METROPOLITAN GOVERNMENT OF NASHVILLE AND DAVIDSON COUNTY

STAFF RECOMMENDATION
1725 Linden Avenue
September 19, 2012

Application: New construction - addition
District: Belmont-Hillsboro Neighborhood Conservation Zoning Overlay
Council District: 18
Map and Parcel Number: 10416019200
Applicant: Dan Cook
Project Lead: Michelle Taylor, michelle.taylor3@nashville.gov

Site Plan

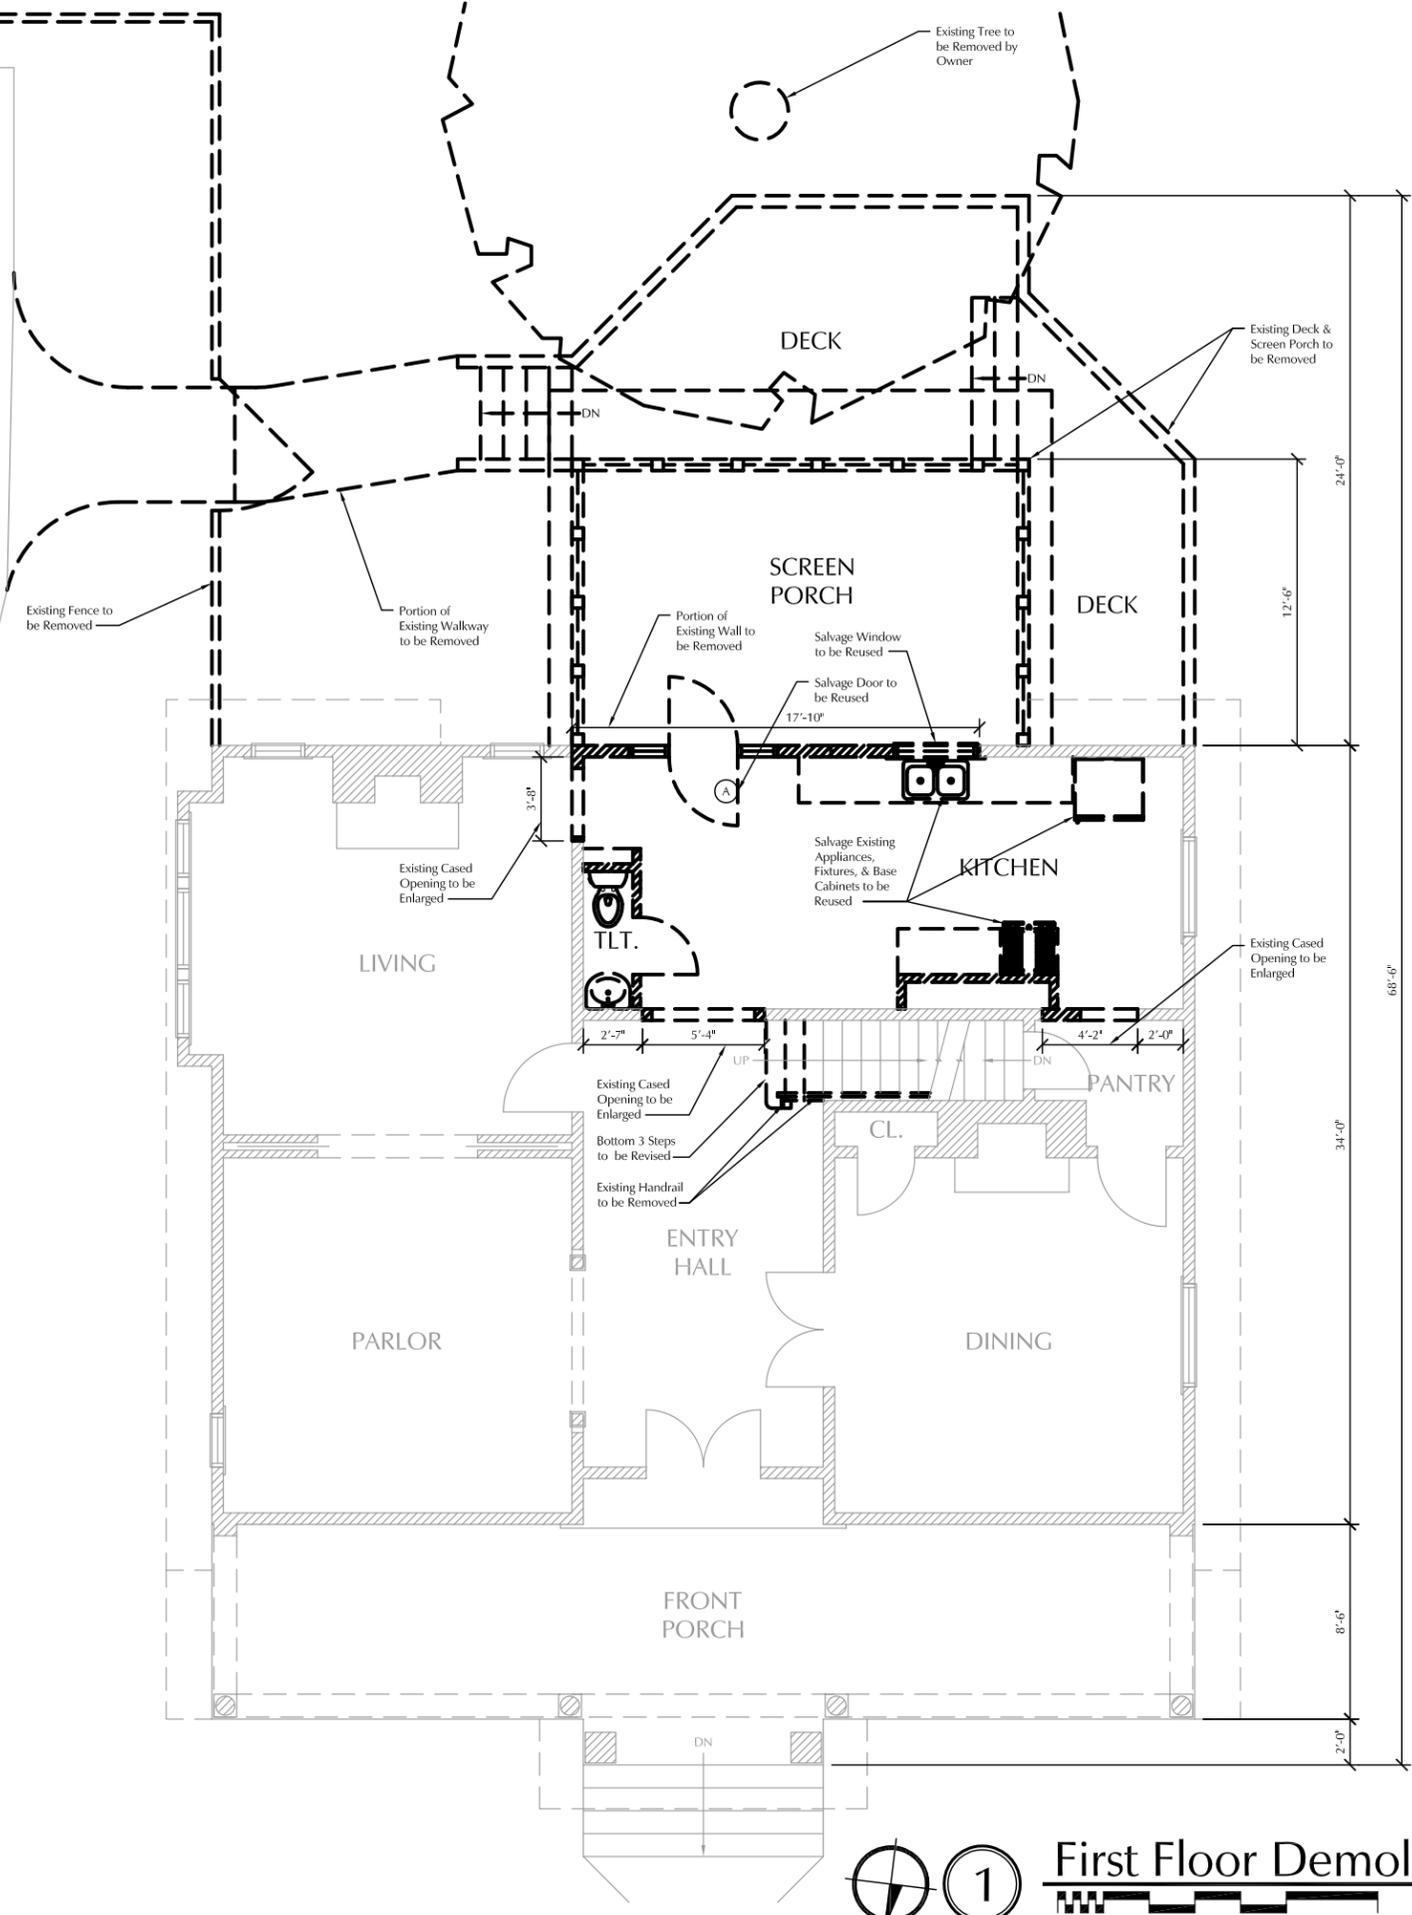
Location and Setback: The proposed two-story rear addition is located entirely behind the house. It is inset, approximately eight feet (8') from both sidewalls of the house, and it meets all bulk zoning requirements for setbacks. Staff finds the location and setbacks of the proposed addition to meet sections II.B.c and II.B.2.a of the *Belmont-Hillsboro*

Appurtenances: A new walkway will connect the existing parking pad to the driveway, material is unknown. Review of the walkway is not necessary for this project.

East Elevation

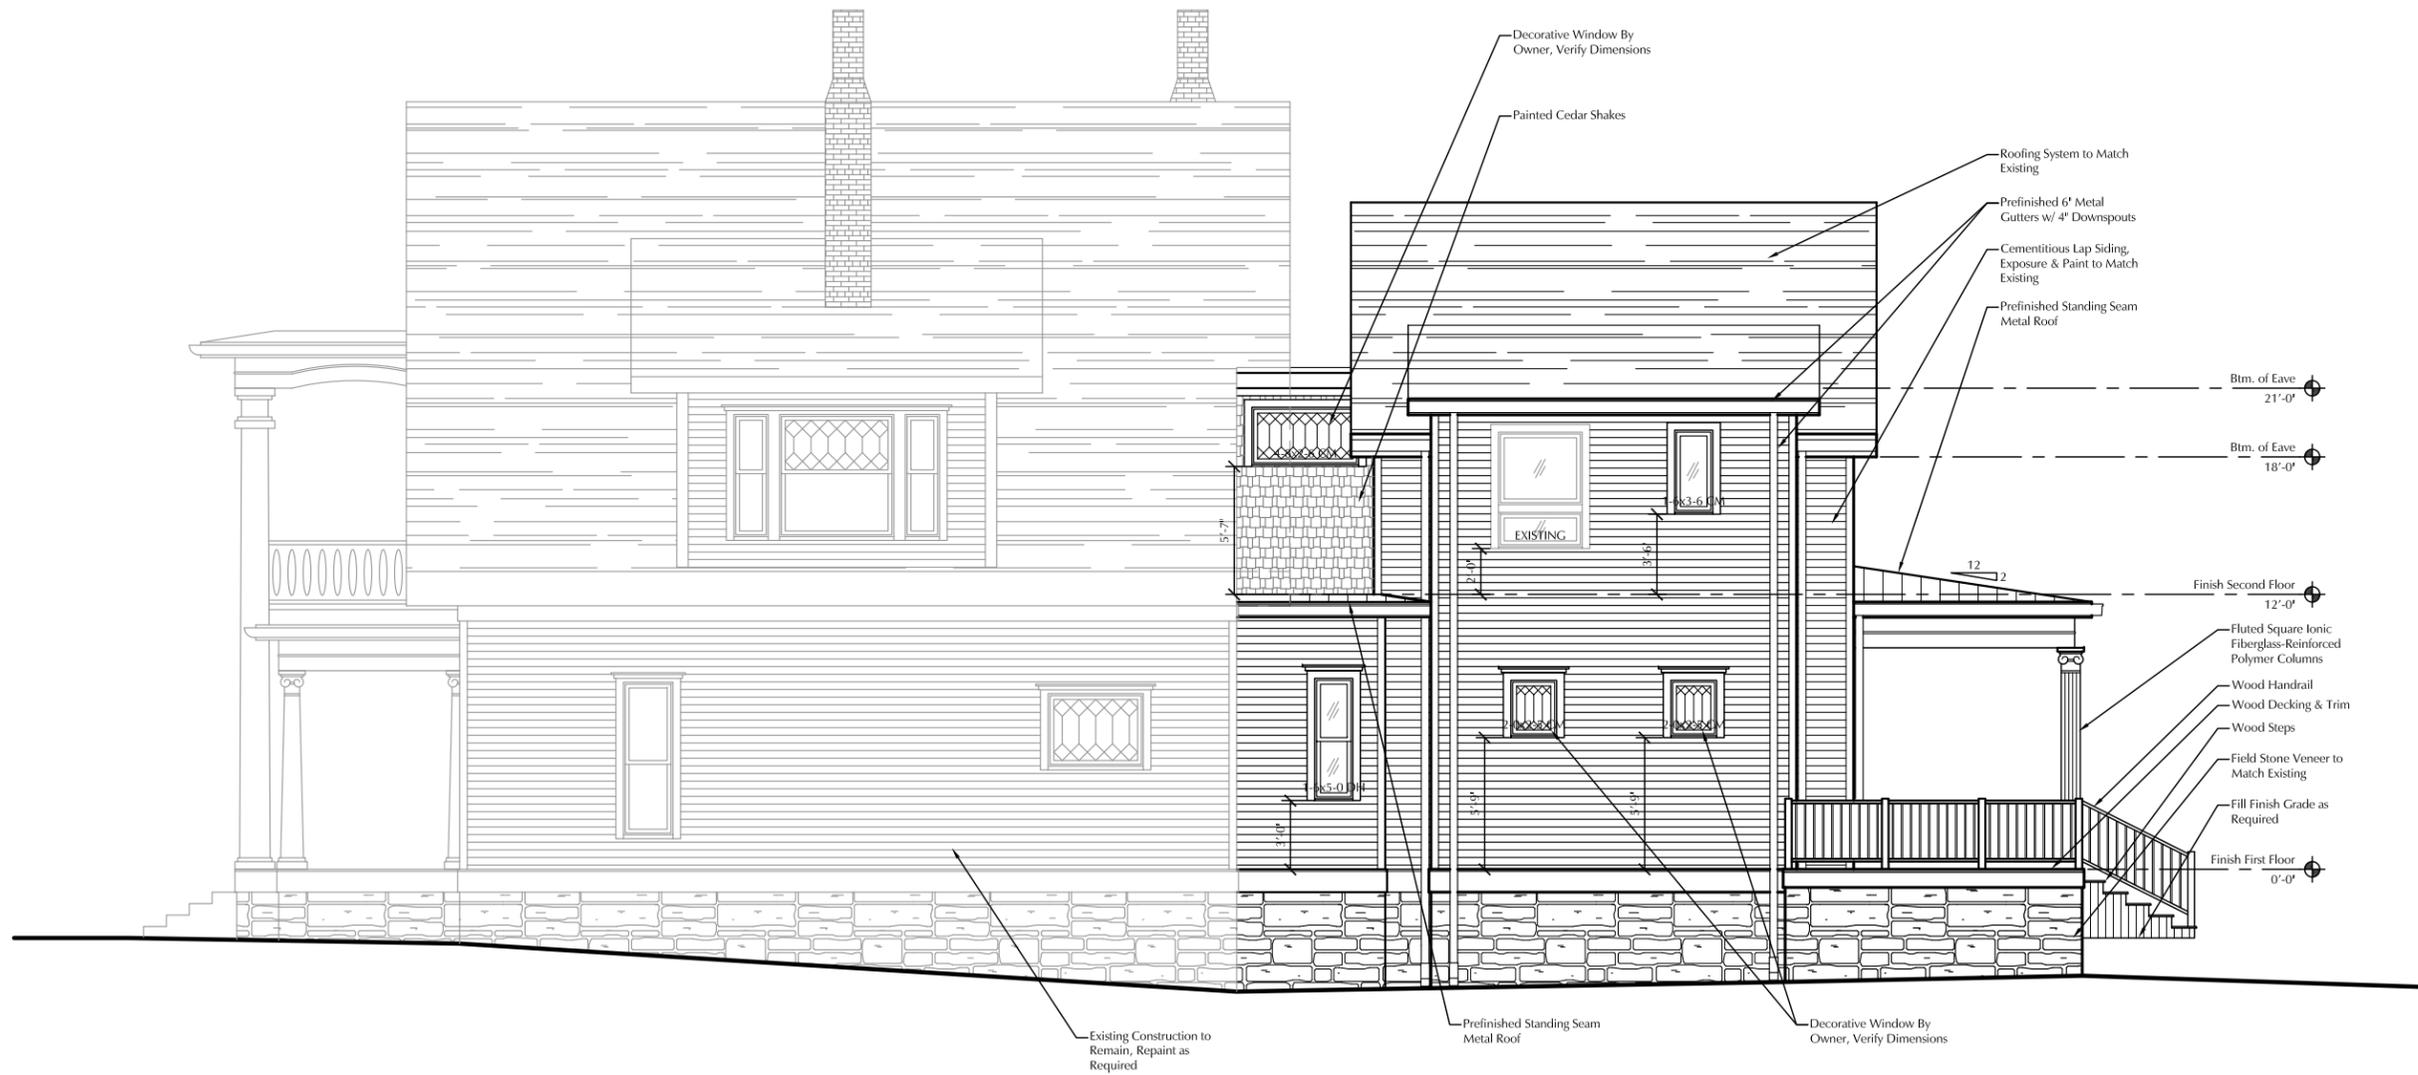
Roof Shape: The historic house has a front gabled roof form with slopes of 12/12 and 12/4. The addition’s roof will tie into the back of the house with a gable that has a slope of 12/12 and 12/4. The left side of the addition incorporates one wall dormer with a slope of 12/4 on the wider portion of the addition. This dormer is minimal and will not be wider than the typical window openings nor will it project beyond the main wall of the existing house.

Proportion and Rhythm of Openings: The dimension and design of windows and doors on the addition are similar to those on the existing house. The primary windows on the addition and on the accessory structure are taller than they are wide and therefore fit the proportions for historic window openings. There are no large expanses of wall space without a window or door opening.

- Staff review a fieldstone veneer sample, the asphalt shingle and metal roof color, and all window and door specifications prior to purchase and installation; and
- Utility locations be reviewed by staff if new locations are planned.
